Planning Commission
June 18, 2024 - 6:00 PM
233 South Main Street, Monroe, Ohio

TO: Members of the Monroe Planning Commission
FROM: Jameson Cole
Planner
DATE: June 18, 2024
RE: Information Packet for June 18, 2024, Planning Commission Meeting at 6:00 p.m.

I. Case No. 2024-6-4—Consideration of a Site Plan for Marathon Gas Station

- Jake Rudemiller of Leesman Engineering, on behalf of Shops of Monroe Crossings LLC, have submitted a site plan application for a gas station and convenience store to be located at the southeast corner of State Route 4, Roden Park Drive, and Coldwater Drive.
- The applicant proposes a 3,500-square-foot building with a convenience store, drive-through, and automotive re-fueling stations.
- The proposed site is 2.29 acres and is zoned C-4 Gateway Commercial PUD.

B RODEN PARK DRIVE ENTRY & SIGN
SCALE: 1"=10'

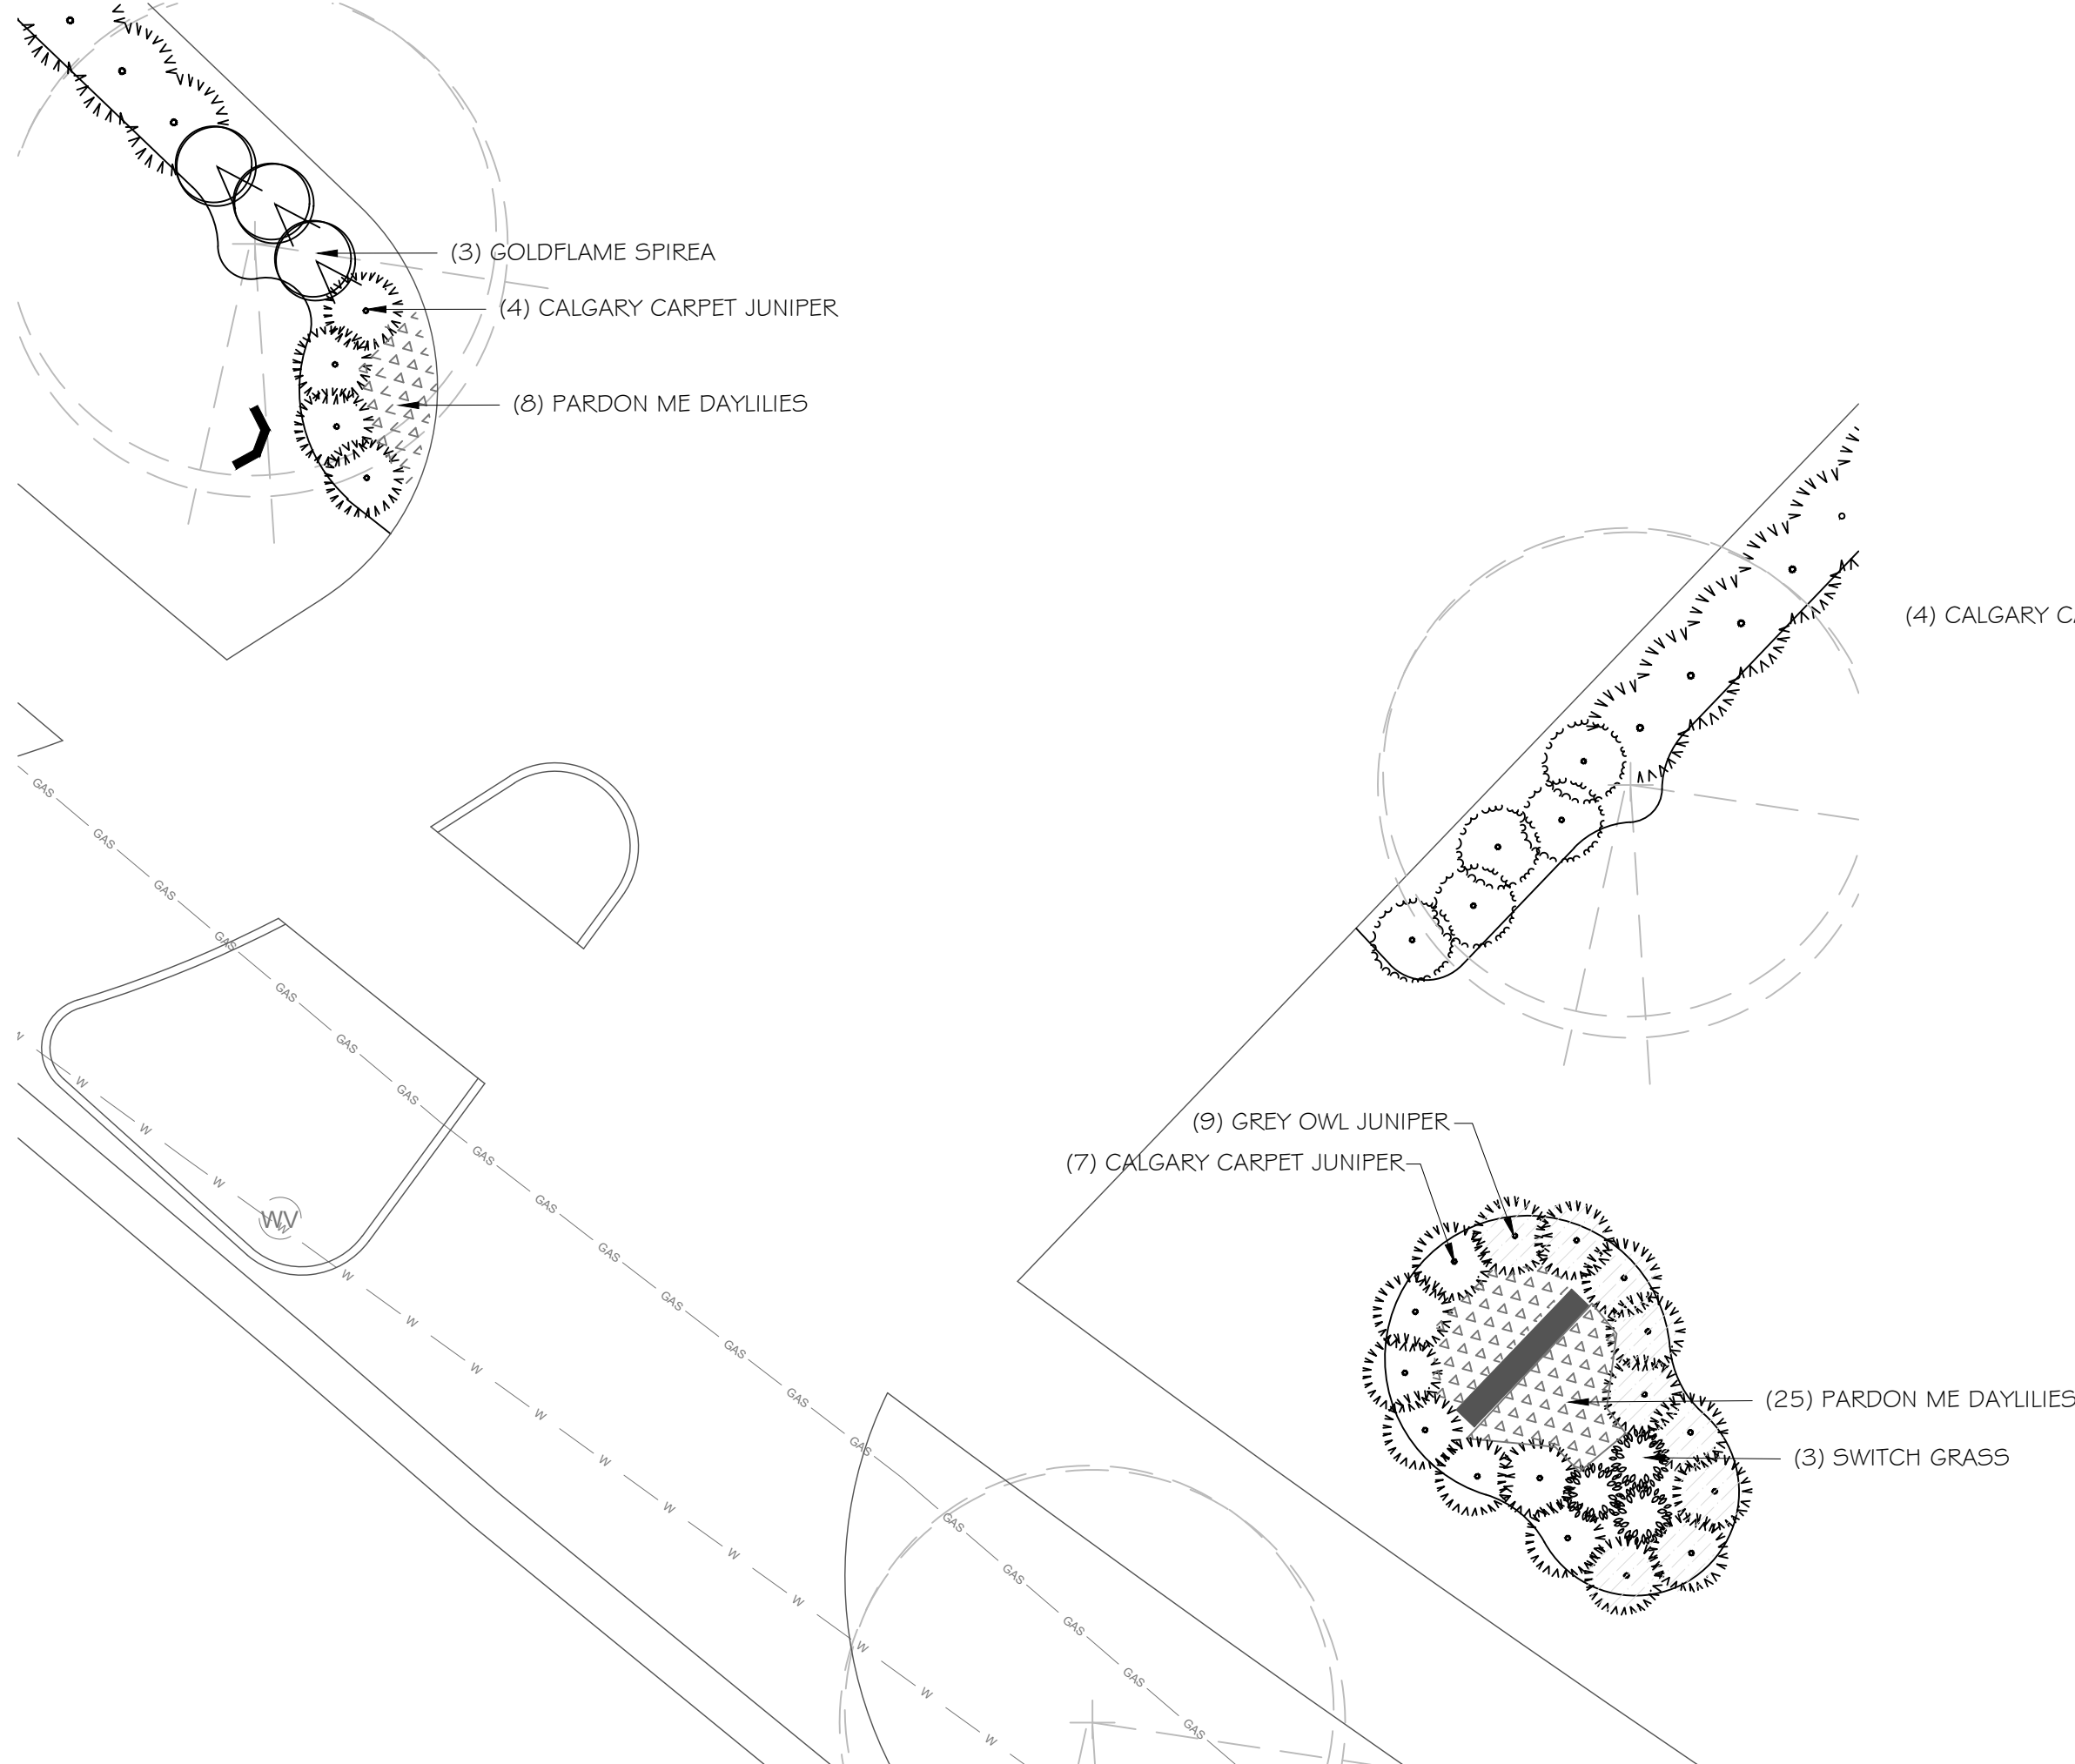
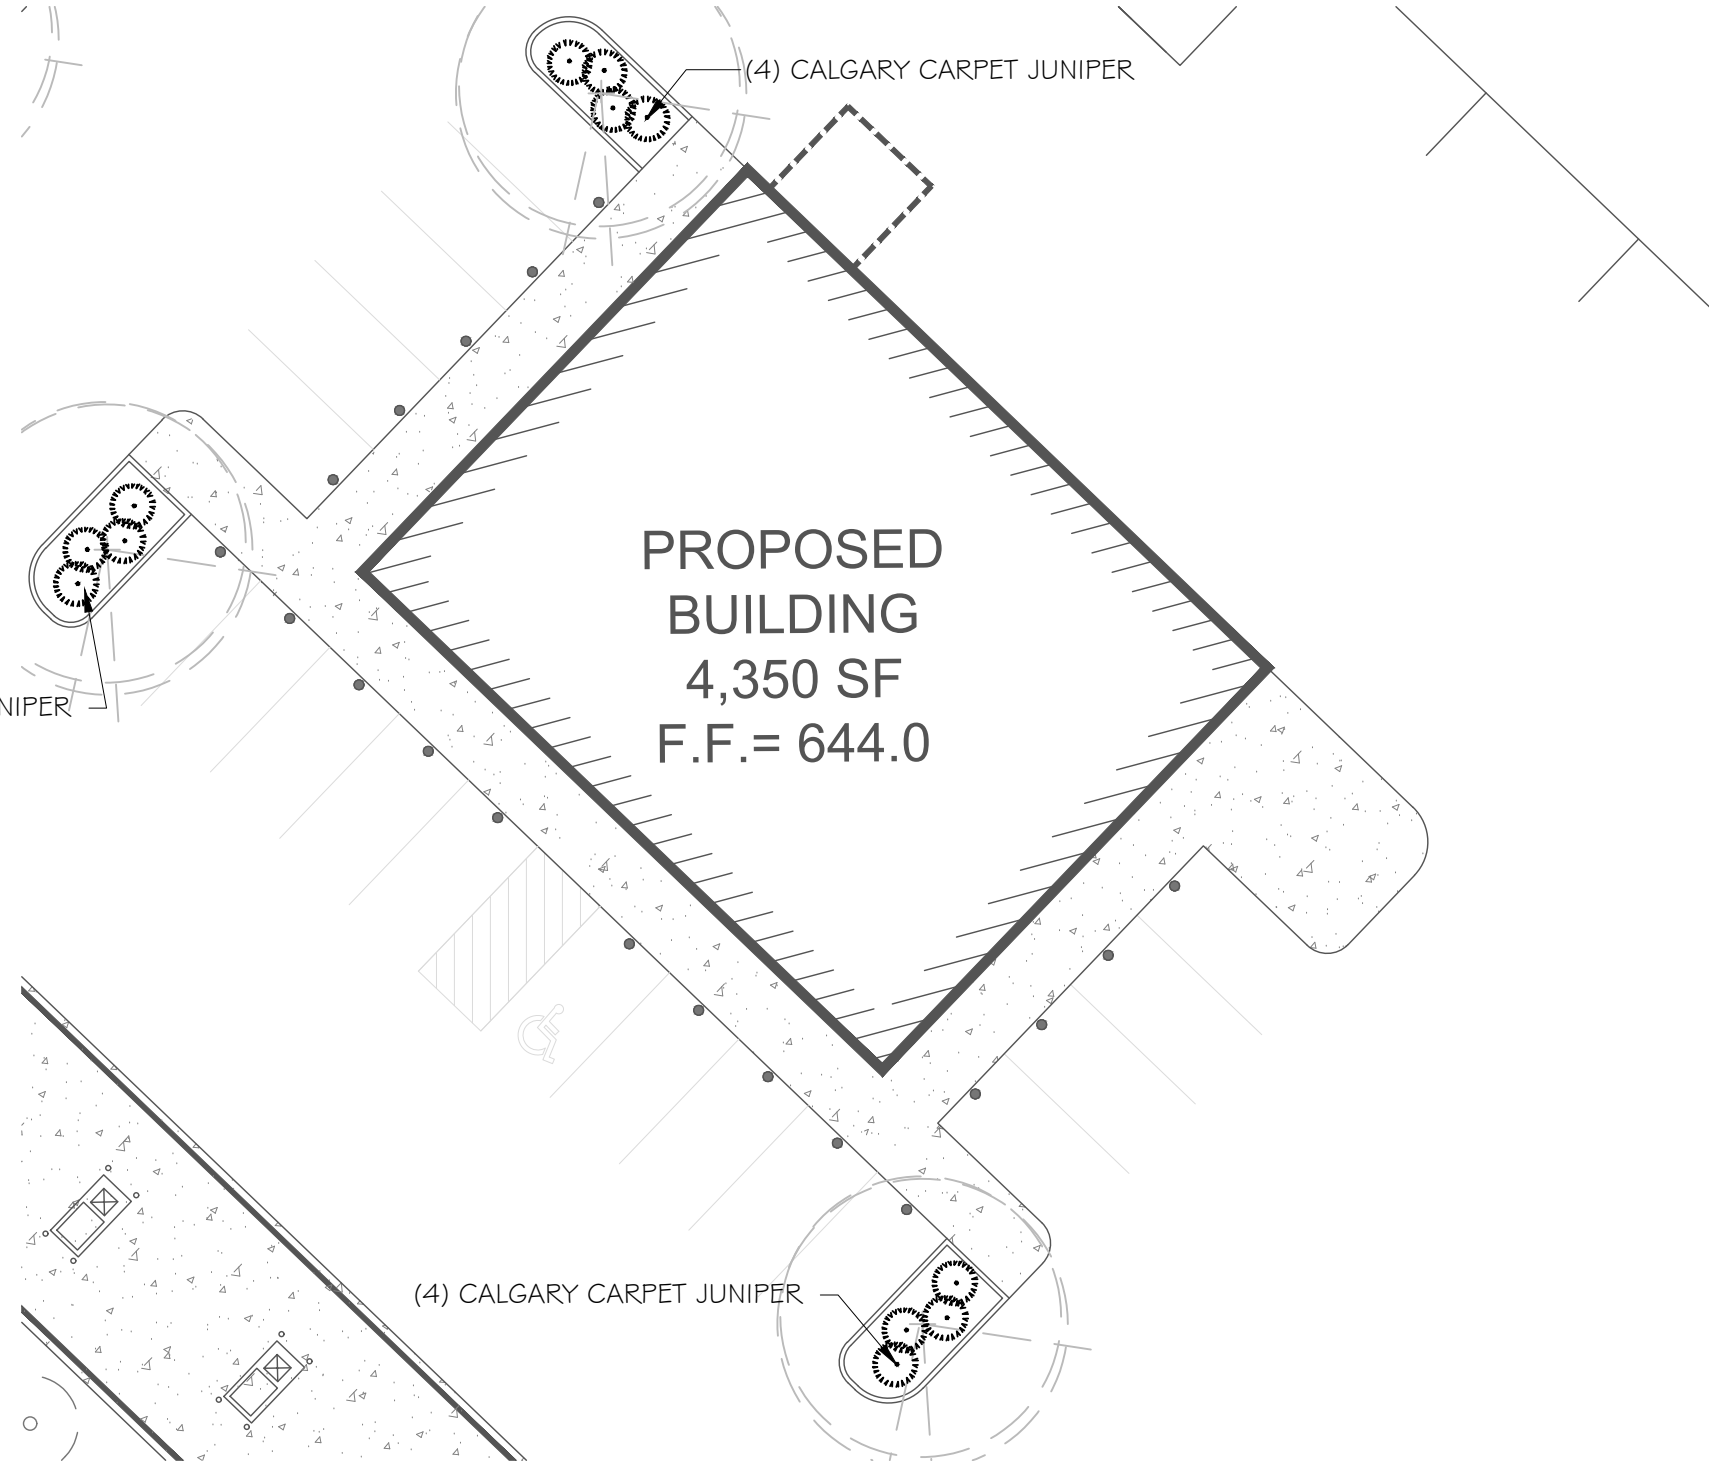
- **Street Trees—**
 - The street trees along Hamilton Middletown Road and Coldwater Drive need to be placed in the tree lawn between the sidewalk and the back of the curb.
- **Landscaping—**
 - The front yard landscaping is required to be a minimum of 20 percent of the required front yard area with a minimum 6-foot-wide area adjacent to the right of way.
- It appears that the trees required as part of the front yard landscaping are missing. Please revise to include trees within the required front yard area.
- **Sidewalk—**
 - The code requires sidewalks along all portions of a parcel that front a public or private street as well as a sidewalk connection to the use. The applicant does not show any connection from the sidewalk to the building.

- Staff recommends approval of the site plan application with the following conditions:
 - The landscape plan be revised based on staff comments to meet code standards.
 - As a reminder, minimum size and species requirements related to landscaping must be met.
 - As a reminder, if ground mounted or rooftop equipment becomes necessary in the future, screening will be required.
 - Revise the site plan to show a pedestrian connection between the sidewalk and the building.
 - All other Staff comments and any future Engineering review requirements are to be addressed.
 - A GIS compatible file of finalized plans be submitted.
